To: Land Use Board  
From: Jack Daniels, Fire Official  
CCed: Jeff Hedden, Fire Chief  
Dave Durand, Deputy Fire Chief  
Frank Setnicky, South Branch Rescue Squad Chief  
File  
Date: February 21, 2022  
Re: Ansuya Riverbend, LLC; Phase 2 & 3 Site Plan Review

The following items are the result of a review of the plans provided to the Clinton Fire Prevention Bureau and the Clinton Fire Department. The plans submitted are dated 12/11/2020, revised 6/11/2021 by Engineering & Land Planning, plan pages 1-15. There was a previous submission of architectural plans dated 6/25/20 that appear not to be a part of this current application. Please advise if the architectural type plans by ksd Architecture plan pages SK-1 through SK-6 are to be used as part of this application. (I highly recommend that a meeting be arranged to discuss the specifics of each proposed structure in order to coordinate the necessary site fire safety aspects.)

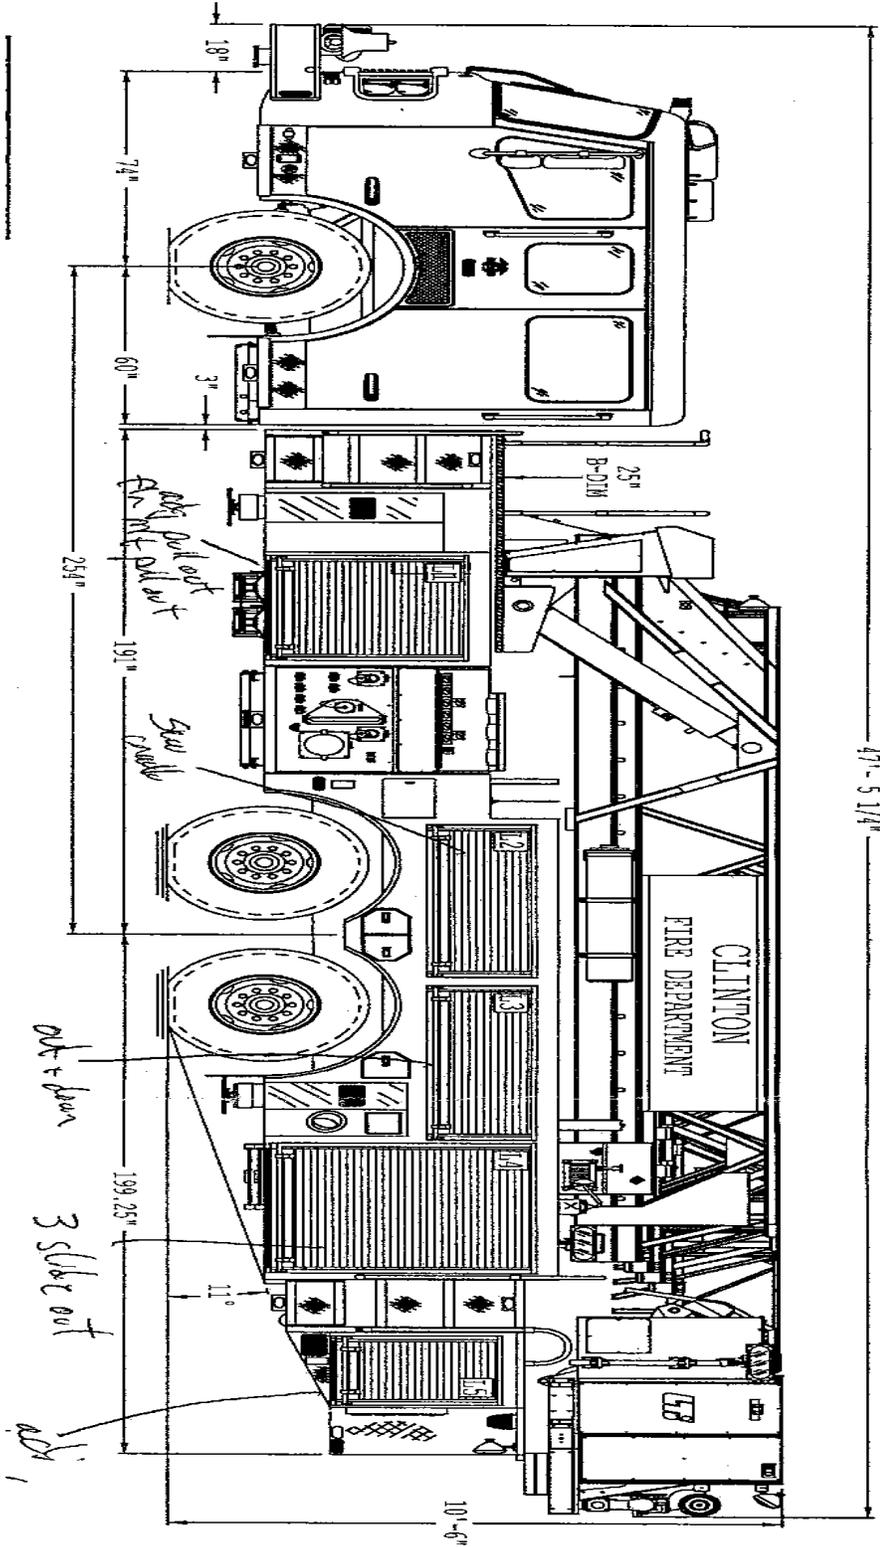
10. Please provide a circulation plan showing the ability of the fire department ladder truck being able to maneuver through the site (Ladder Truck detail included below).
